2.5 Geology, Seismology, and Geotechnical Engineering

In Section 2.5, “Geology, Seismology and Geotechnical Engineering,” of the site safety evaluation report (SSAR), the applicant, System Energy Resources, Inc. (SERI), provided a detailed description of the geological, seismological, and geotechnical engineering properties of the early site permit (ESP) site. In this safety evaluation report (SER), Section 2.5.1, “Regional Geology,” describes basic geological and seismological data, especially the data published since 1986 for the area within a 200-mile radius of the ESP site, and presents updated seismic sources. Section 2.5.2, “Vibratory Ground Motion,” evaluates the vibratory ground motion for the ESP site and analyzes the safe-shutdown earthquake (SSE) ground motion. Section 2.5.3, “Surface Faulting,” describes the potential for surface faulting at or near the surface of the ESP site. Section 2.5.4, “Stability of Subsurface Materials and Foundations,” presents the results of site geotechnical investigations and discusses the stability of subsurface materials and foundations. Section 2.5.5, “Stability of Slopes,” defers the analyses for slope stability at the site and dam perf

FIGURE 2.5-92
 REV. 0
 1522d Grand Gulf

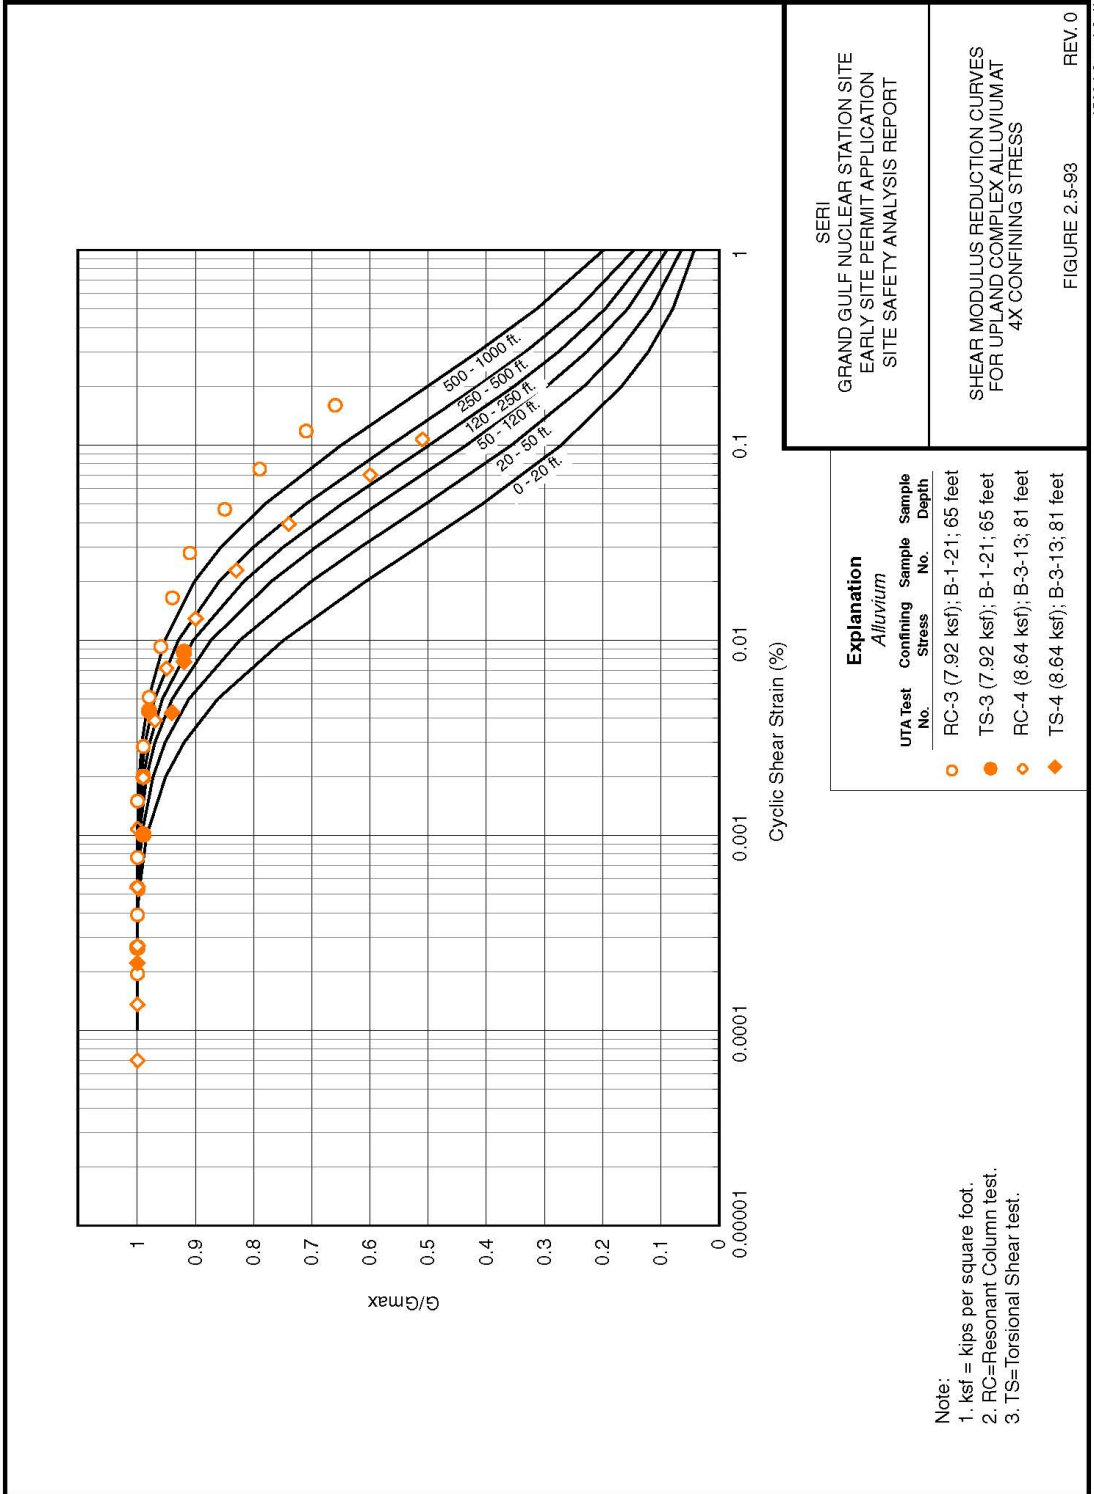
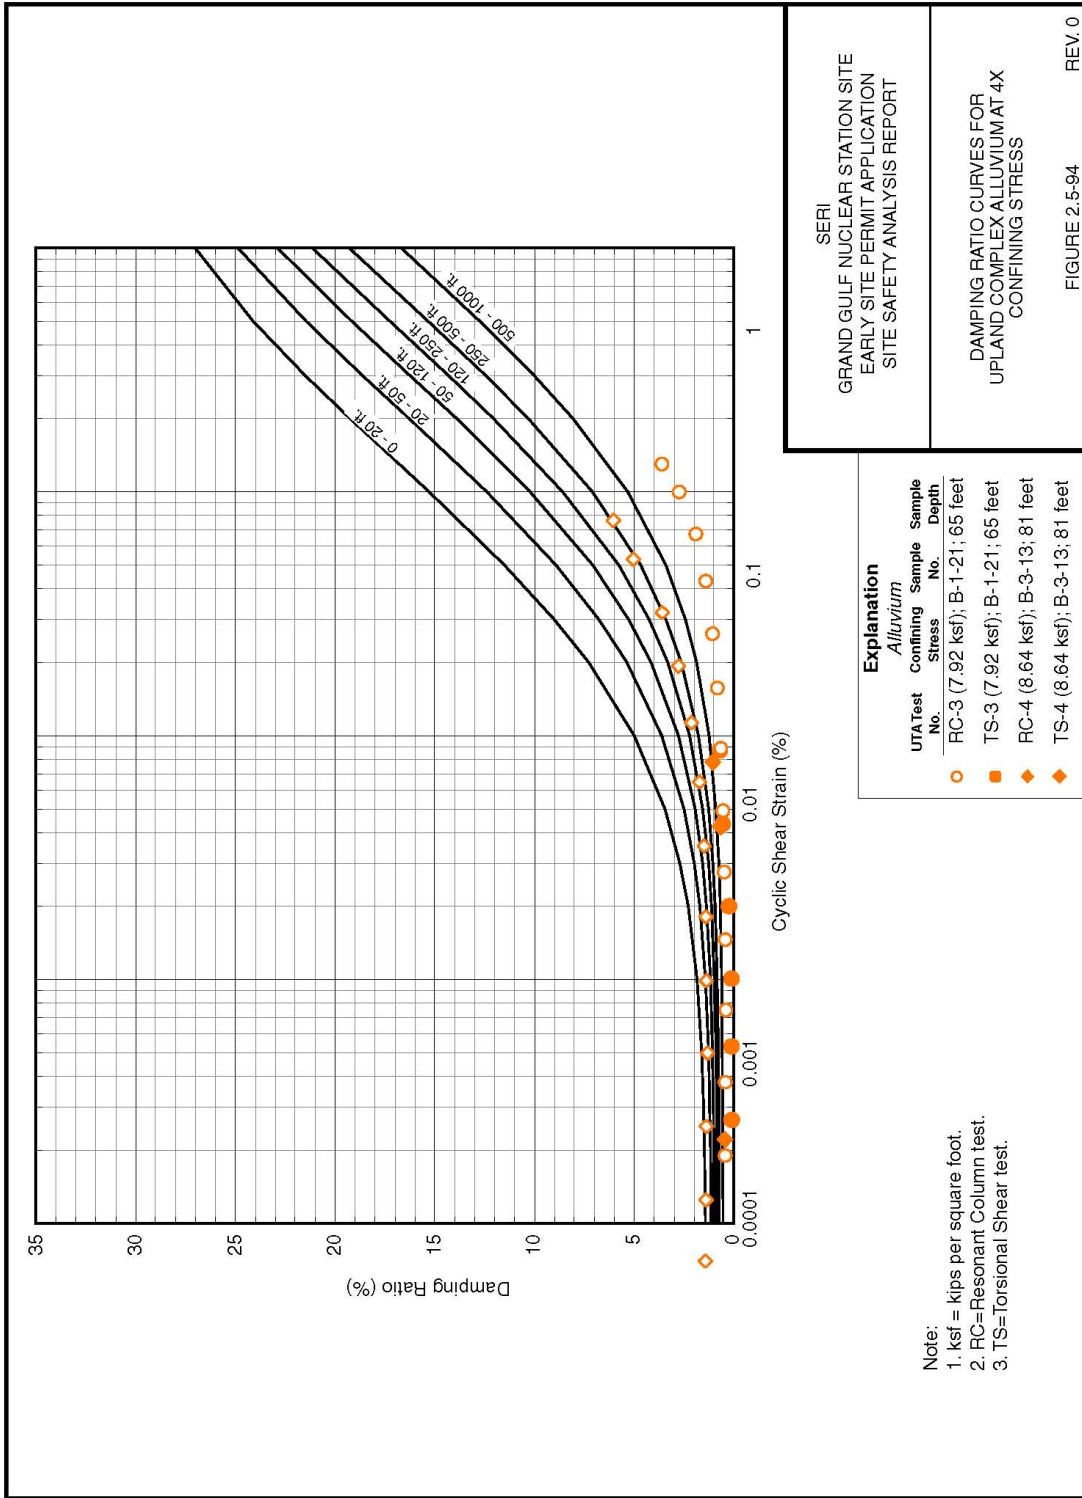
- Section 11.0 of ER-02 suggests that the laboratory results for specimens UTEXAS 1, 2, and 6 should be corrected to account for the effects of sample disturbance and/or underestimation of effective confining stress.

In RAI 2.5.4-7, the staff asked the applicant to provide its rationale for not incorporating these effects in the site response calculations and to evaluate the potential impact of these modifications on the computed surface UHS. In its response, the applicant referred to its response to RAI 2.5.4-6 and stated that the analysis and selection of the appropriate EPRI-TR curves for shear modulus reduction and hysteretic damping fully account for the effects of possible disturbance to the test specimens resulting from stress release during sampling, as well as possible movements during testing. The applicant considered the effects of sample relaxation by examining the results from testing soils at both the estimated in situ confining stress and 4 times the estimated in situ confining stress. The applicant plotted these two data sets together on the EPRI-TR base curves as shown in Figures 2.5.4-5 through 2.5.4-12, which replicate SSAR Figures 2.5.4-87 to 2.5-94 and Figures 2.5.4-13 and 2.5.4-14. The two data sets were weighted to select the most representative EPRI-TR curve.

The applicant also stated in its response that SSAR Section 2.5.4.1.7 presents the results of the dynamic laboratory tests plotted on the families of EPRI modulus reduction and damping curves for loess, Upland Alluvium, and Old Alluvium. However, because it did not indicate which of the EPRI curves should be selected for the site response analyses, the applicant will revise these SSAR figures to indicate the recommended curves used in the site response analyses. The applicant also stated that SSAR Section 2.5.4.1.7 discusses the rationale for adopting the EPRI curves. Specifically, the shape of the curves defined by the site-specific laboratory tests are similar to the shape of the EPRI curves. The comparison of the laboratory and EPRI-TR curves indicates that the raw laboratory data show less modulus reduction and lower damping values than the EPRI curves for the same depths. The applicant also explained that this is likely because EPRI developed these curves for normally consolidated Holocene silty and clayey sands, whereas the soils at the ESP site are both older and overconsolidated. In addition, the applicant noted that the laboratory test results must be adjusted for the effects of stress relief sample disturbance. As indicated in SSAR Table 2.5-26, the ratio of the shear wave velocities measured in the laboratory versus the field is generally less than unity. The ratio of the shear wave velocities measured in the laboratory for specimens consolidated to 4 times the estimated in situ stress versus the field-measured velocities are on the order of unity. This suggests that the additional sample consolidation produces results that better match the in situ field conditions of these soils.

(Figures 2.5.4-17 and 2.5.4-18) (Figures 2.5.4-4-2 and 2.5.4-4-3 of the RAI response)

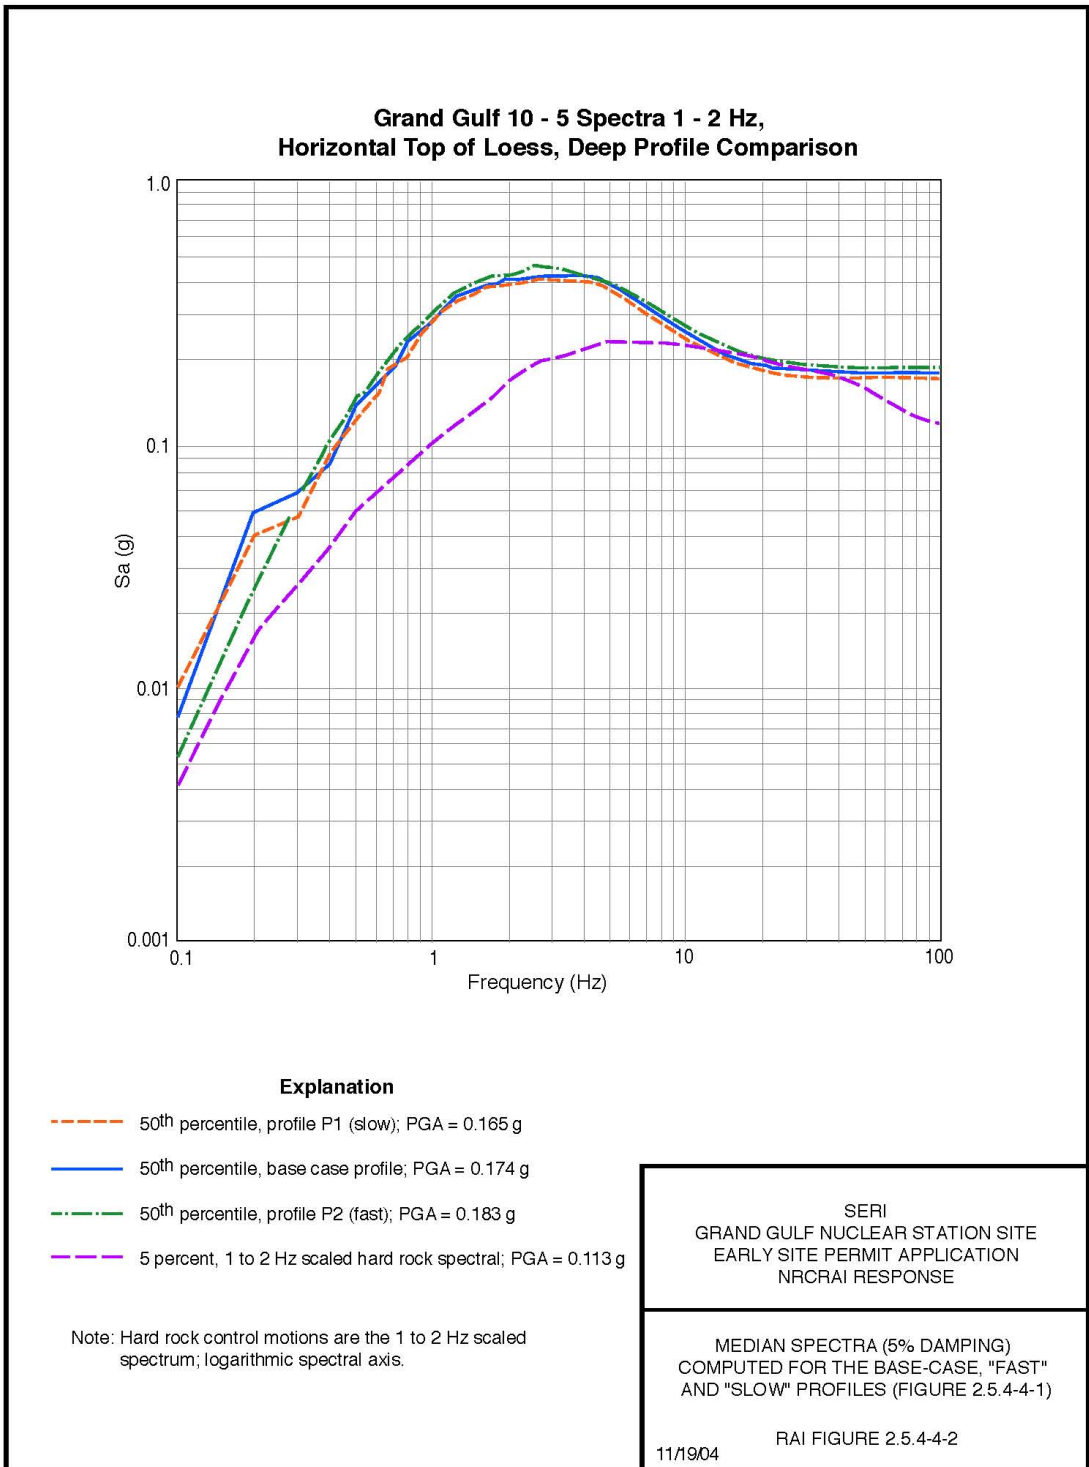
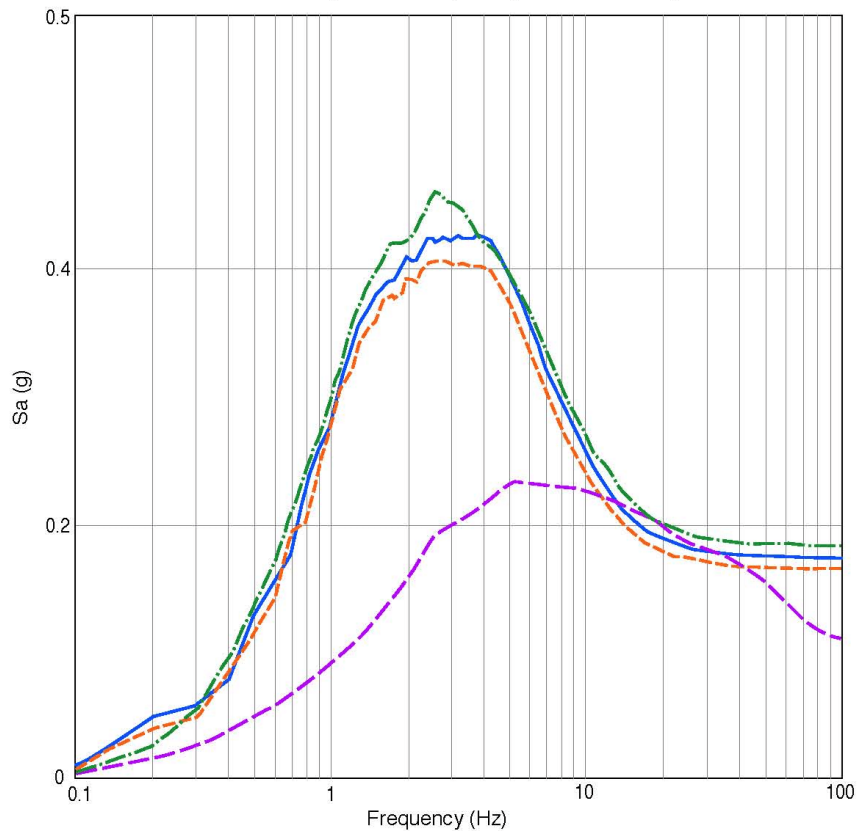
In seismic response analyses, shear and compression wave velocities, material densities, and strain-dependent modulus reduction and hysteretic damping data are necessary for the entire soil column extending to the depth considered in the site response evaluation. As indicated in Figure 2.5.2-4, the applicant assumed that the hard rock, with a shear wave velocity of 9186 fps, is located at a depth of 3281 feet and adopted a generic profile proposed for the Mississippi embayment region. This shear wave profile is relatively smooth, with a shear wave velocity varying from approximately 820 fps at the ground surface to a value of 9186 fps at depth of 3281 feet. The applicant also replaced the upper 197 feet of the profile with a site-specific velocity profile generated by the geophysical program described previously. Therefore, of the entire 3281 feet of the profile, only the upper 197 feet are reasonably constrained. No site-specific information is available below this depth. However, it is a common practice for the sites where critical facilities are located to have one or more base case shear wave velocity models from site-specific data (e.g., well logs and deep borings) and then to generate soil UHS using the probabilistic method of NUREG/CR-6728. In RAI 2.5.4-4, the staff asked the applicant to provide the basis for selecting the generic base case velocity model as opposed to any other model that might be generated from available information for the site and its environs. In its

response, the applicant stated that no measurements of velocity profiles are known to exist within tens of kilometers of the site. Based on extensive measurements near the Memphis area and surrounding regions, the differences in stratigraphy and wave velocities between the lowlands and uplands extend only to shallow depths (upper several hundred feet), are reasonably well characterized, and are generally considered uniform throughout the embayment.

To compare the median motions computed for the three profiles, the applicant stated that it used the 1- to 2-Hz-scaled 10^{-5} APE spectrum as control motions to excite the column at low as well as high frequency since it is quite similar to the UHS and sufficiently broad band (i.e., large magnitude) compared to the UHS. Figures 2.5.4-17 and 2.5.4-18 show the resulting soil median motions in both logarithmic and linear spectral axis, respectively. As expected, little difference exists between the motions computed for the three profiles from 0.3 to 100 Hz. At peak acceleration, the fast and slow profiles show about a 5-percent increase and decrease, respectively, in motions, as compared to the base case profile. The motions reflecting the fast profile generally exceed those of the base case by about 5 percent. The largest exceedance is near a resonance at about 3 Hz, at which the fast profile motions exceed the base case motions by about 10 percent. Based on regional geology as well as experience with similar geology in deep basins, this fast profile is extremely unlikely and would receive very low weight in a hazard analysis. The applicant stated that these site response analyses illustrate the general insensitivity of the motions to the nature of velocity gradients likely to exist in the deep materials beneath the site.

Figure 2.5.5-1 from RAI Figure 2.5.5.1-1

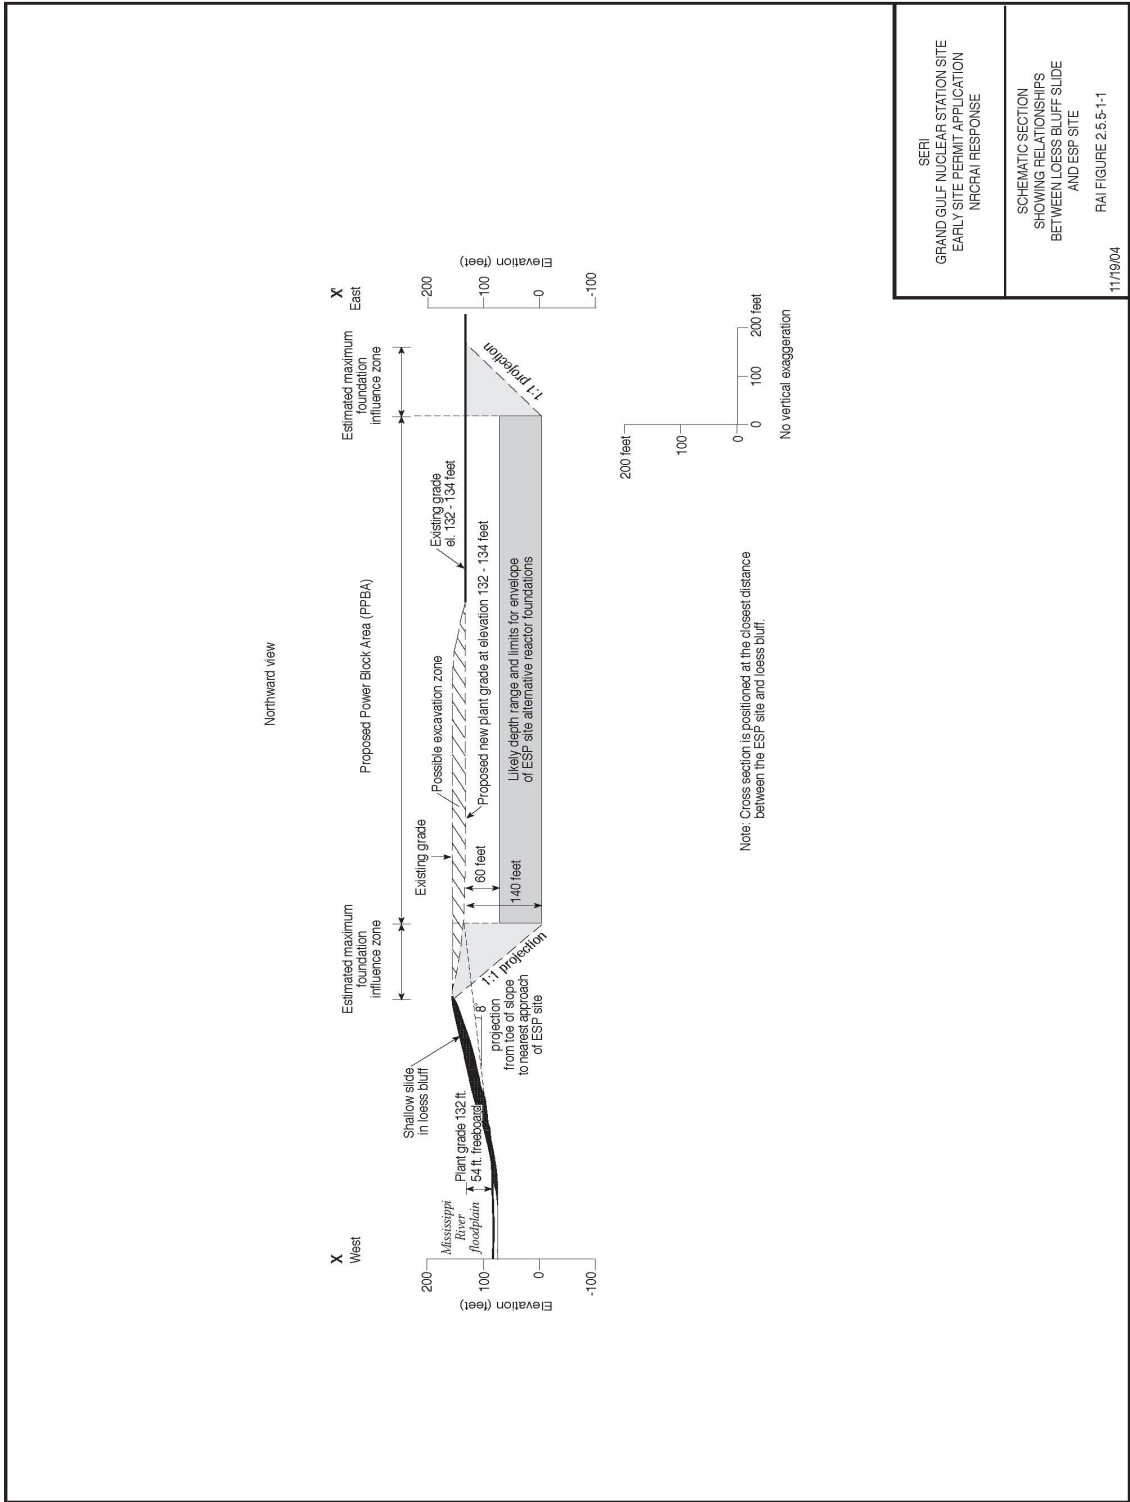
stability of slopes in the area to support its application for the ESP, except that the applicant must provide additional information to address the identified open item. On this basis, the staff concludes that the slope stability assessment presented in this SSAR section is acceptable.
